**JOINT REGIONAL PLANNING PANEL
(Central Region)**

JRPP No	2016SYE082
DA Number	16/117
Local Government Area	Bayside Council
Proposed Development	Integrated Development Application for the construction of two residential flat buildings incorporating two x 4 storey podiums, 2 x 14 storey towers containing a total of 239 residential units, a retail tenancy, a childcare centre, private recreation facilities, at-grade and above ground 'sleeved' podium parking for 255 cars and 24,648sqm of gross floor area; construction of a new north-south private publically accessible open space link; associated excavation, earthworks and landscaping.
Street Address	671-683 Gardeners Road, Mascot, NSW 2020
Applicant	Karimbla Constructions Services (NSW) Pty Ltd
No. of Submissions	Nil
Regional Development Criteria	Development with a CIV of \$70,689,331.00
List of All Relevant s79C(1)(a) Matters	<ul style="list-style-type: none"> • Environmental Planning & Assessment Act 1979, Part 4 – Development Assessment & Schedule 4A – Development for which regional panels may be authorised to exercise consent authority functions of councils • Environmental Planning & Assessment Regulation 2000, Part 6 – Procedure

Figure 10: Council's proposed changes to the balcony of U103 (Level 1, Building D)

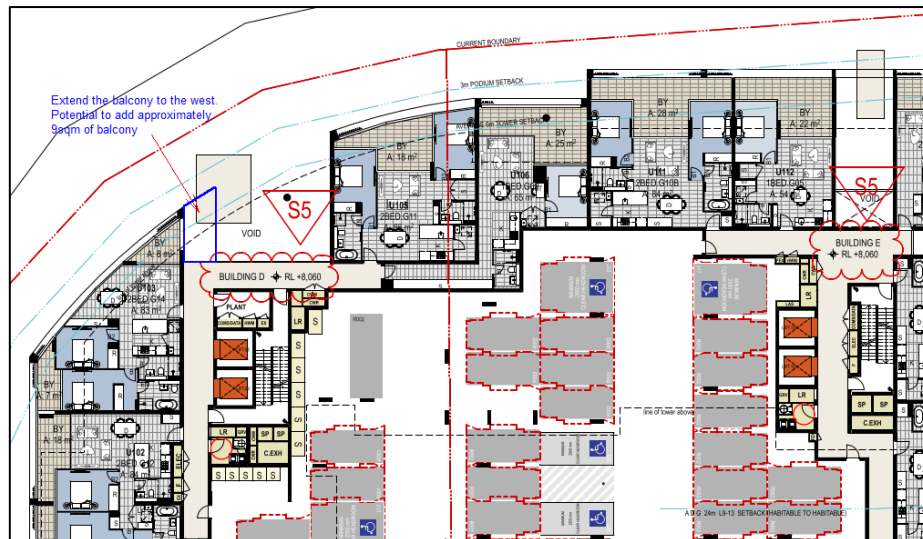
Unit Number	Minimum Balcony Size Required	Balcony Size Proposed (off the living area)	Comment
U103 (2 bed unit)	10sqm	8sqm	No furniture layout shown. Potential to extend the balcony eastward and fill in the void. Potential to add an additional 9sqm of balcony. The provision of a highlight window should be made to allow natural light into the corridor. Refer to Figure 10 below.
U203 (2 bed unit)	10sqm	8sqm	No furniture layout shown. Potential to extend the balcony eastward and fill in the void. Potential to add an additional 6sqm of balcony. The provision of a highlight window should be made to allow natural light into the corridor. Refer to Figure 11 below.
U303 (2 bed unit)	10sqm	8sqm	No furniture layout shown. Potential to extend the balcony eastward and fill in the void. Potential to add an additional 6sqm of balcony. The provision of a highlight window should be made to allow natural light into the corridor. Refer to Figure 11 below.

The proposed changes above are demonstrated in the marked-up plans below.

A condition has been recommended that the balconies above be extended to ensure compliance with the minimum balcony size requirement of the ADG but to also satisfy Part 4C.4.2 (Family Friendly Apartment Buildings), Control 6 of the BBDGP 2013 which requires that the private outdoor space is to be clearly visible from the kitchen. Additionally, the proposed changes outlined above and in the recommended condition will significantly improve the internal and external amenity of residents of these units without compromising visual privacy and overlooking through non-compliant building separation distances.

Figure 13: Council's proposed changes to the balconies of U523-1323, U522-1322 & U521-1321 (Level 5 – 13, Building F)

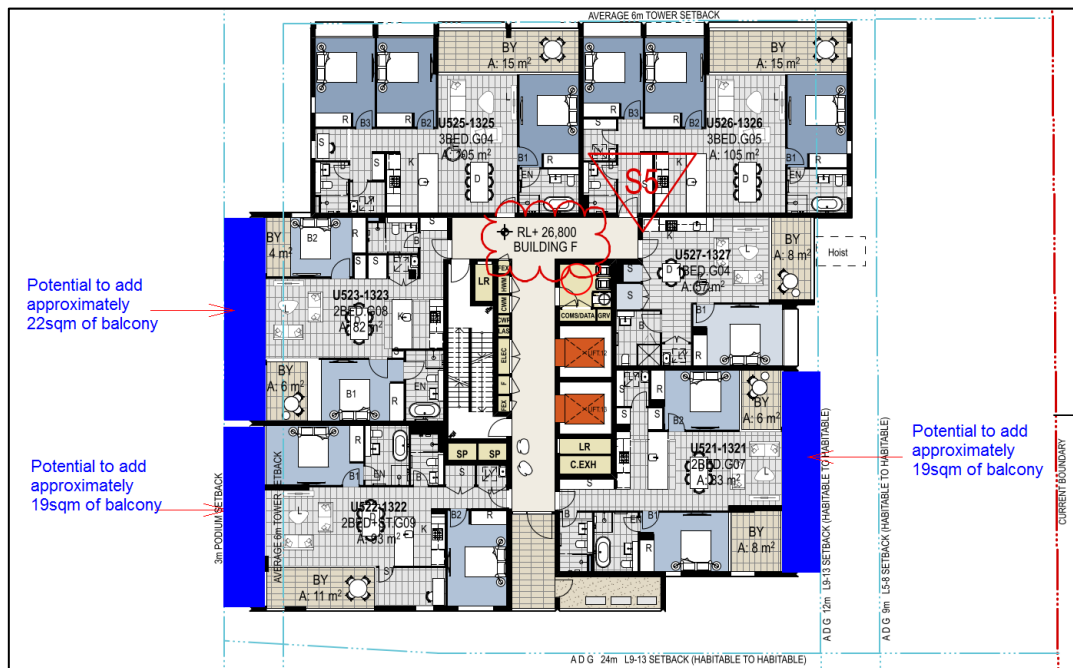
Unit Number	Minimum Balcony Size Required	Balcony Size Proposed (off the living area)	Comment
			meet the 6m tower setback line. Potential to add an additional 10sqm of balcony. Refer to Figure 12 below.
U523-U1323 (2 bed unit)	10sqm	6sqm	Furniture layout shown. Short by 4sqm. Potential to extend the balcony westward to meet the 3m podium setback line. This will provide a 25.7m separation distance between Building E and F which complies. Potential to add an additional 22sqm of balcony. Refer to Figure 13 below.
U521-U1321 (2 bed unit)	10sqm	8sqm	Furniture layout shown. Short by 2sqm. Potential to extend the balcony eastward to meet the Level 9-13, 12m setback line. This will provide a 12m separation distance to the eastern boundary which complies. Potential to add an additional 19sqm of balcony. Refer to Figure 13 below.
U522-1322 (2 bed unit)	10sqm	11sqm	Balcony complies however there is potential to extend the balcony westward to meet the 3m podium setback line. This will provide a 25.7m separation distance between Building E and F which complies and will provide consistency with the proposed changes to U523-U1323 noted above. Potential to add an additional 19sqm of balcony. Refer to Figure 13 below.

All apartments provide direct sight lines from the kitchen to the outdoor spaces. However, approximately 27 (11%) of apartments have an acute angled view from the kitchen to the balcony. These apartments are U515-1315, U523-1323 and U521-1321.

This can be corrected by bringing the balcony out slightly so that it wraps around the open plan living area. This would not compromise building separation as internally there is a separation distance of 28m, on the eastern side there is approximately 2m leeway until the 12m boundary setback line and on the northern side there is approximately 1.5m – 2.3m leeway until the 6m boundary setback fronting Gardeners Road.
